PROPOSED REVISION

NEW RESIDENCE AND DETACHED ADU
1033 CORTEZ AVENUE
BURLINGAME, CALIFORNIA
APN: 026-166-040
OWNER: RAYMOND WONG

09.30.25 CHS changes

PROPOSED LOWER FLOOR PLAN
1/4" = 1'-0"

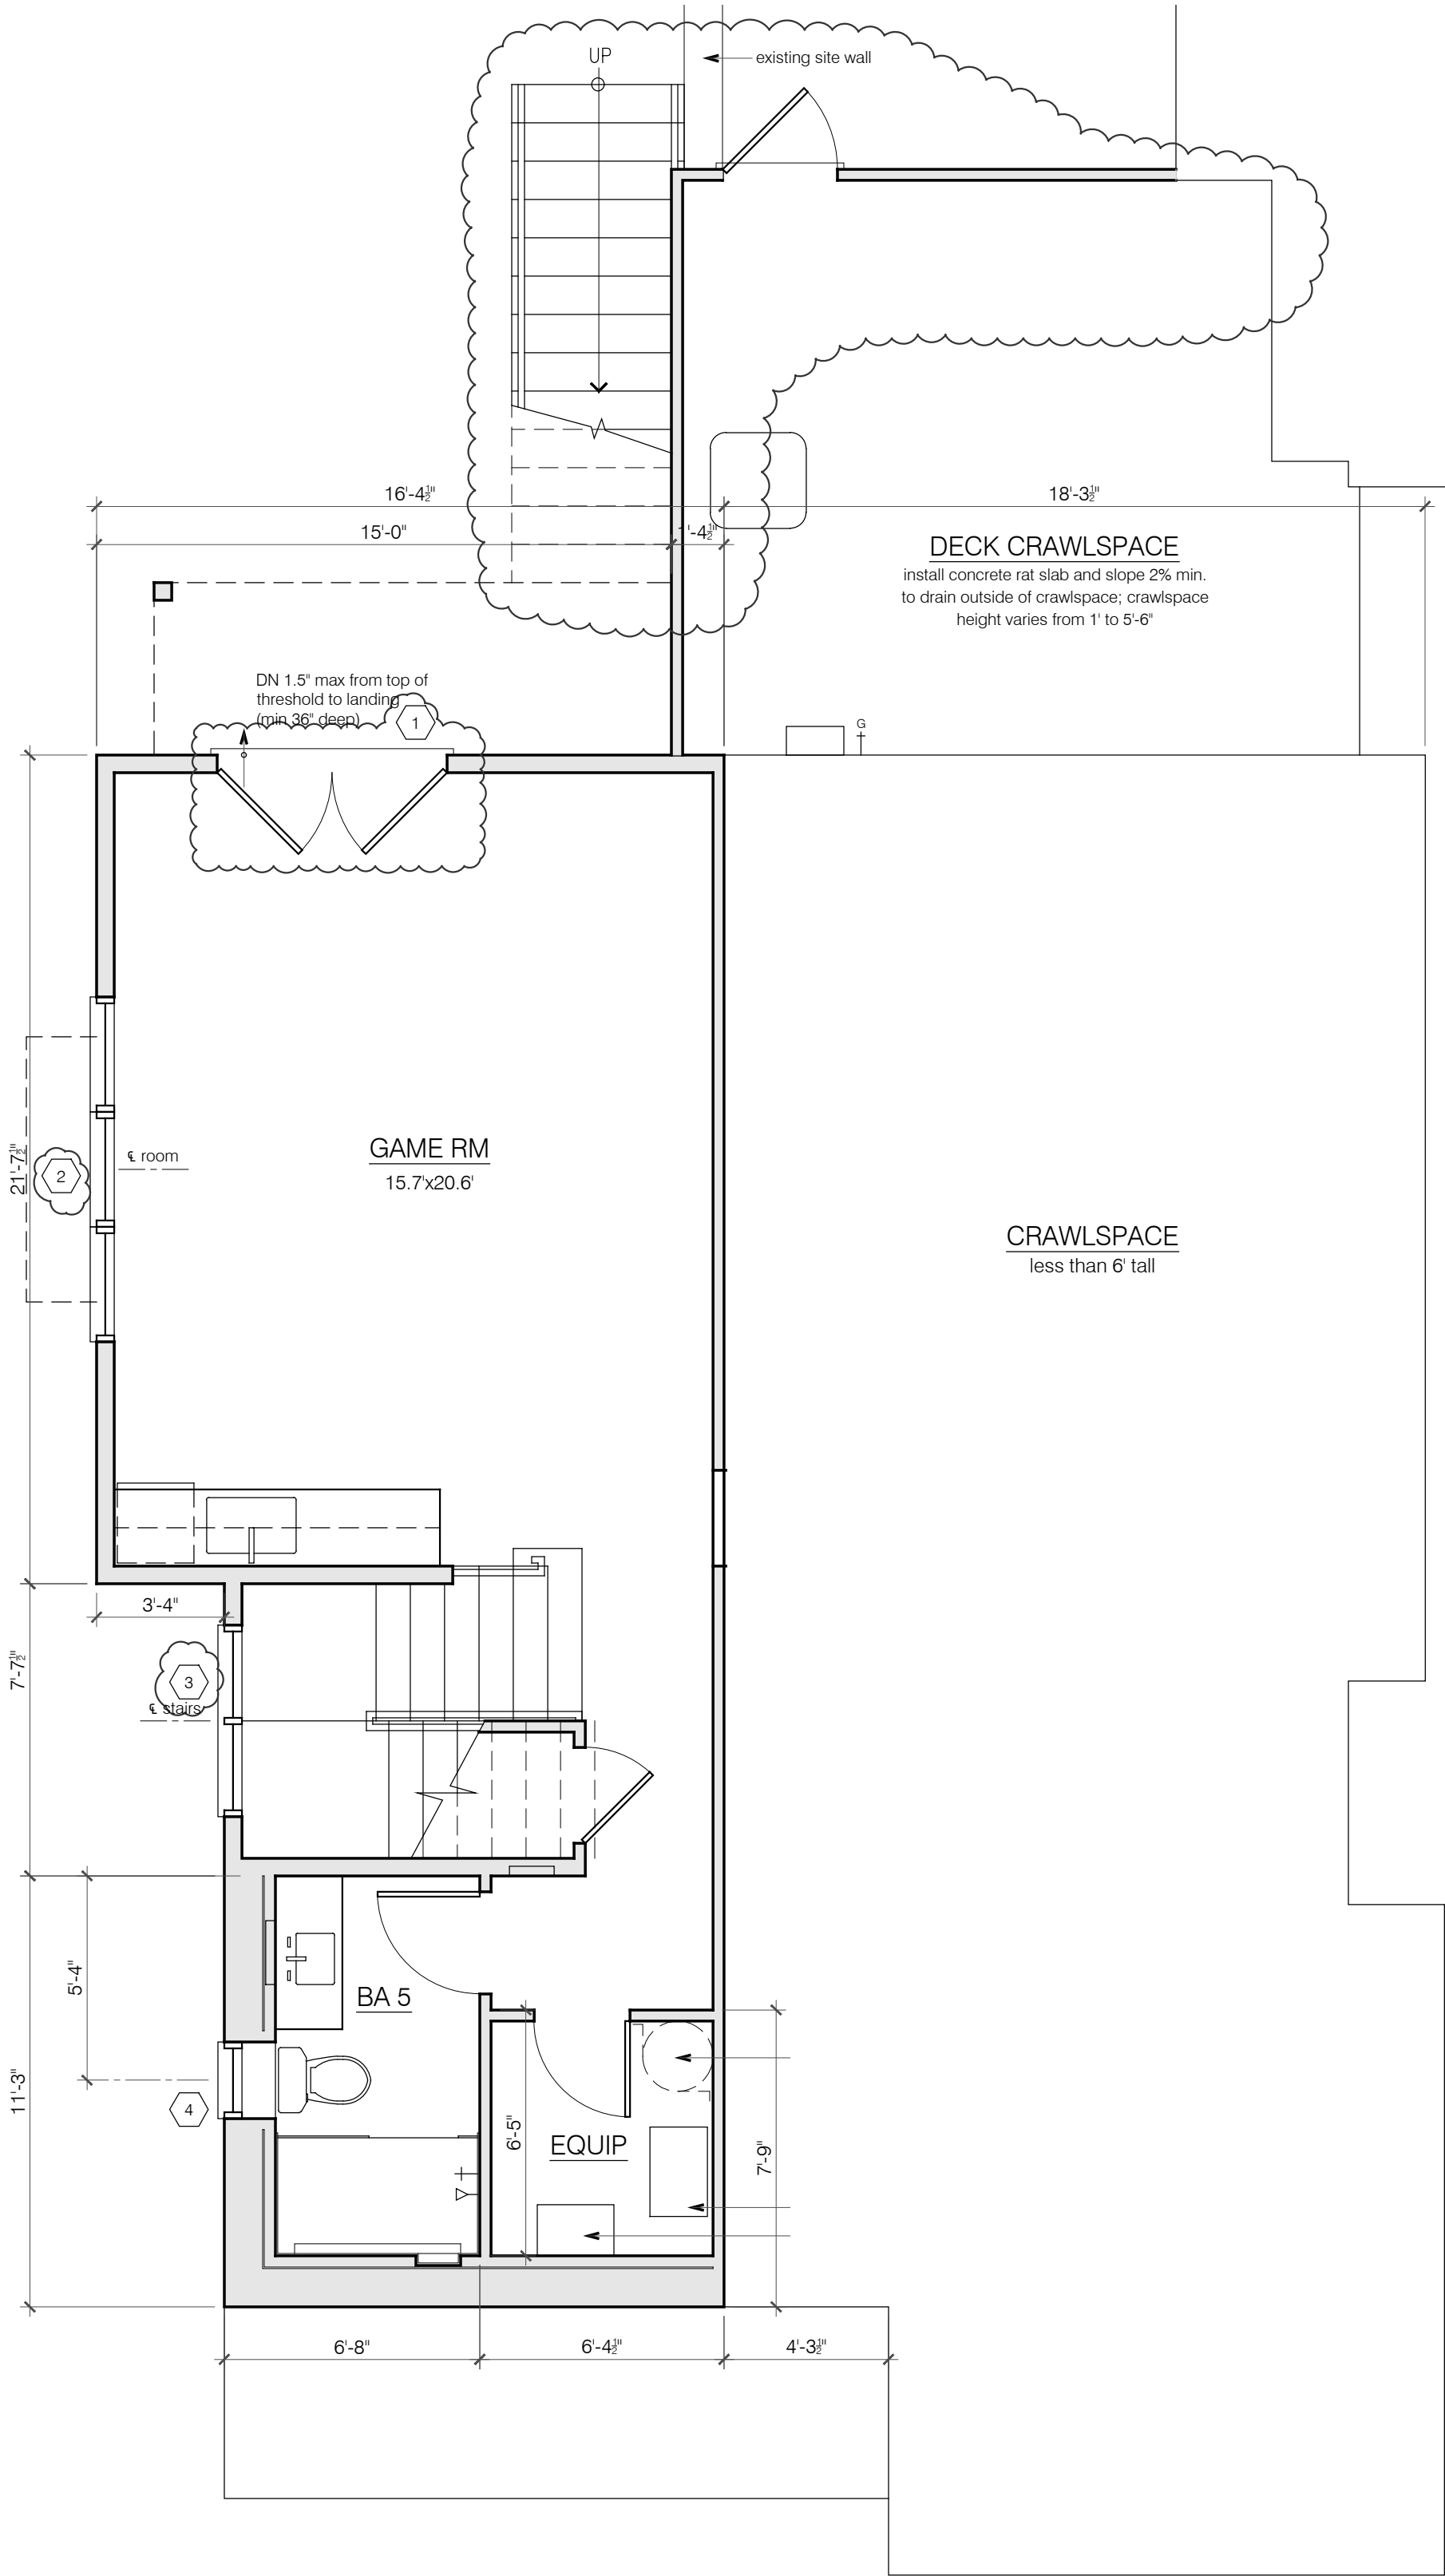
reduced width, increased height
increased height
increased height

PROPOSED FIRST FLOOR PLAN

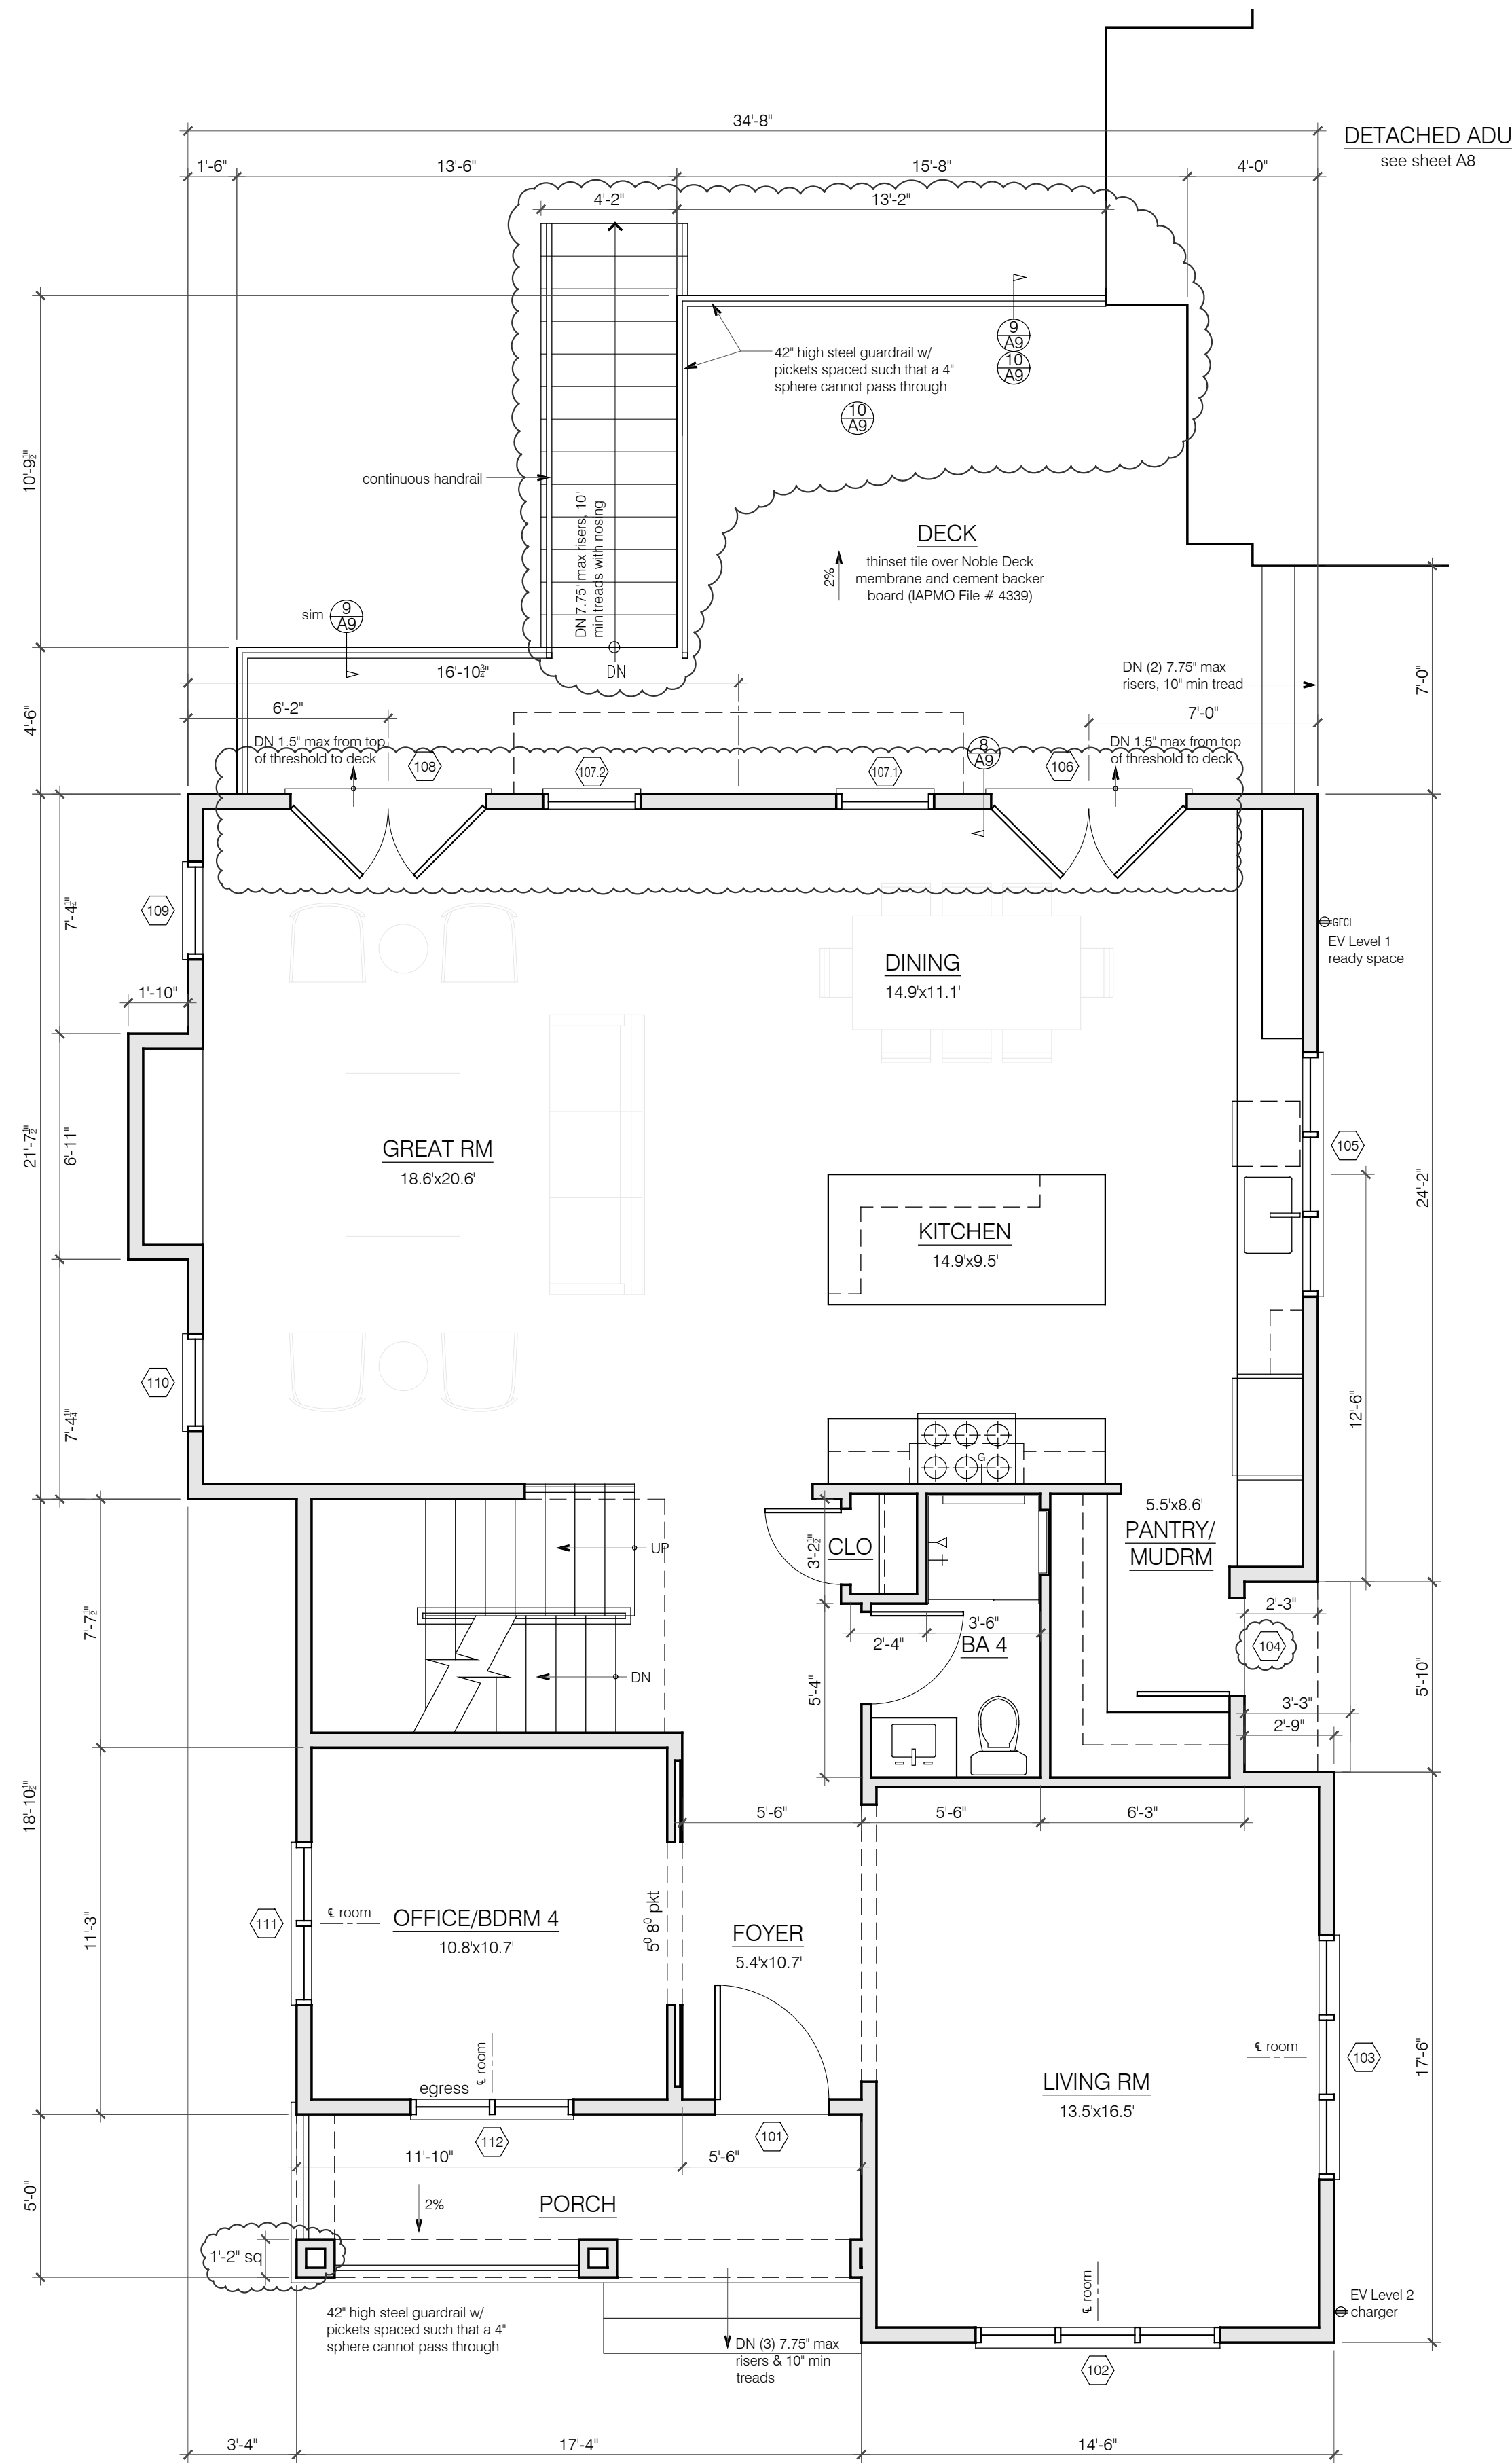
CLOUDED CHANGES AT FLOOR PLANS
INDICATE FLOOR PLAN OR WINDOW
LOCATION/WIDTH CHANGES ONLY.
REFER TO SCHEDULE FOR CHANGES
IN WINDOW HEIGHTS.

PROPOSED SECOND FLOOR PLAN
1/4"=1'-0"

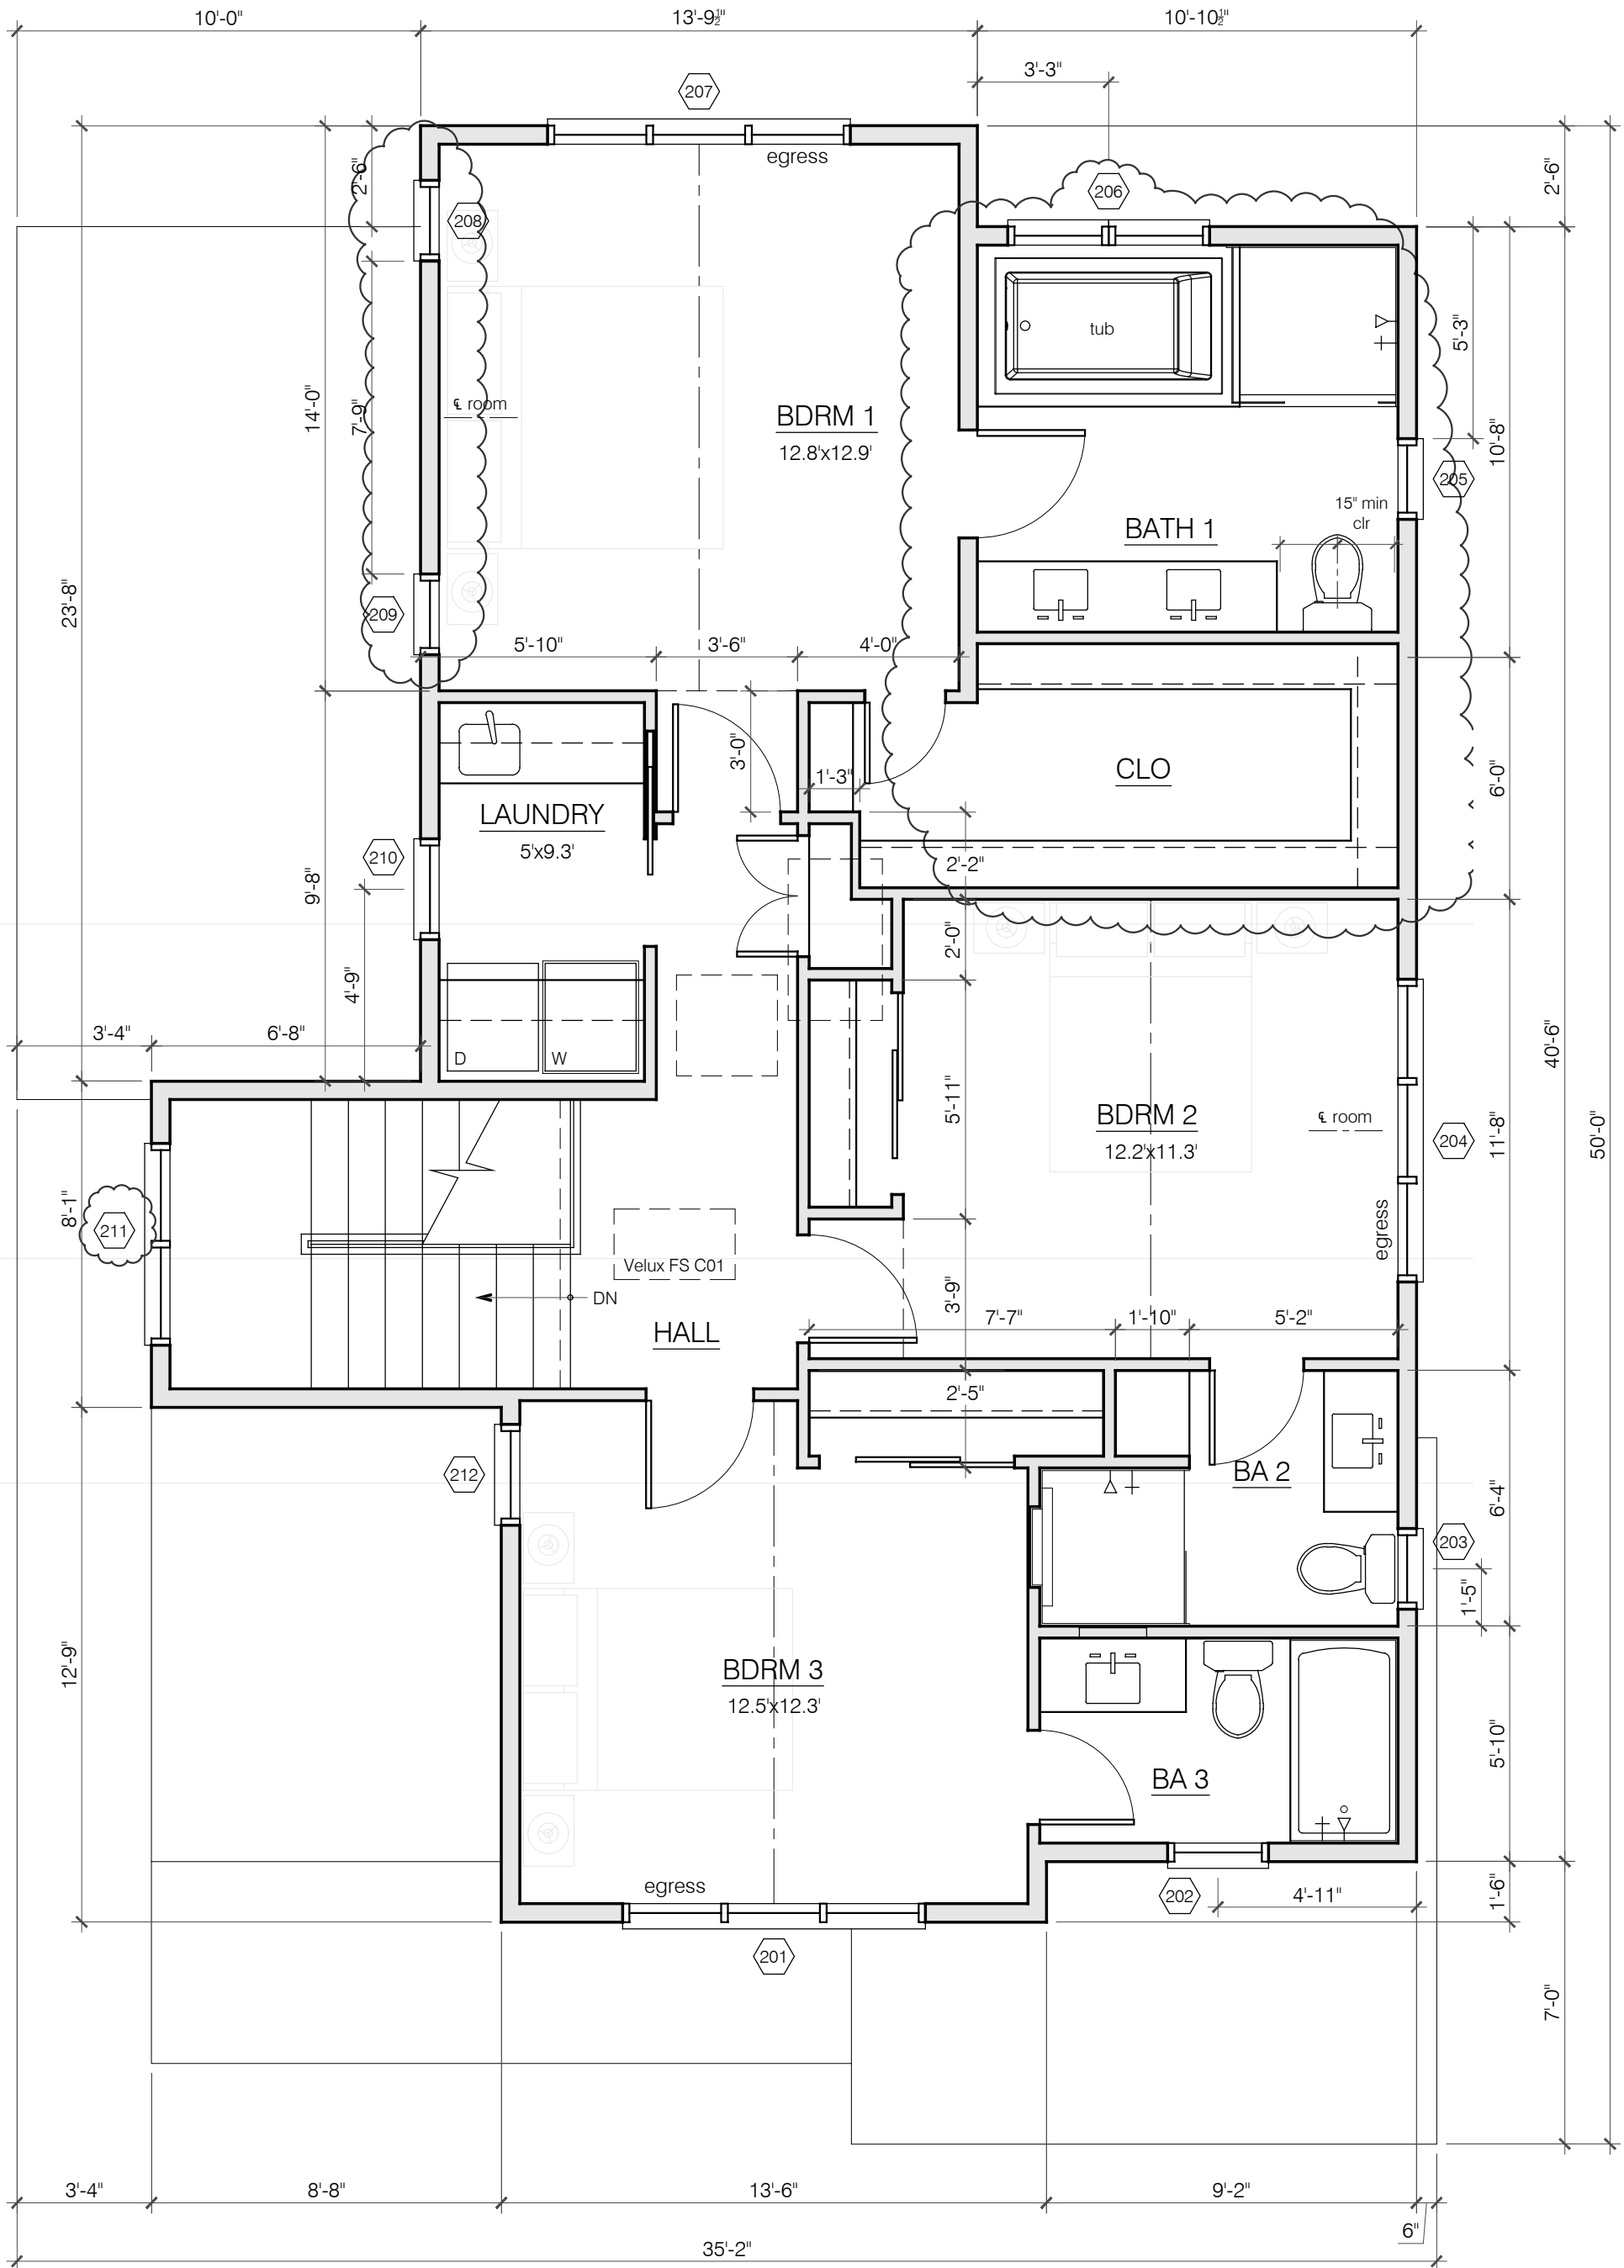
changed from windows to doors
changed from folding door to fxd door, reduced width
changed from folding door to fxd door, reduced width
changed from windows to doors

changed from 2 high windows to single window obscure
window widened (faces rear)

high window above bed changed to window flanking bed
high window above bed changed to window flanking bed

height increased
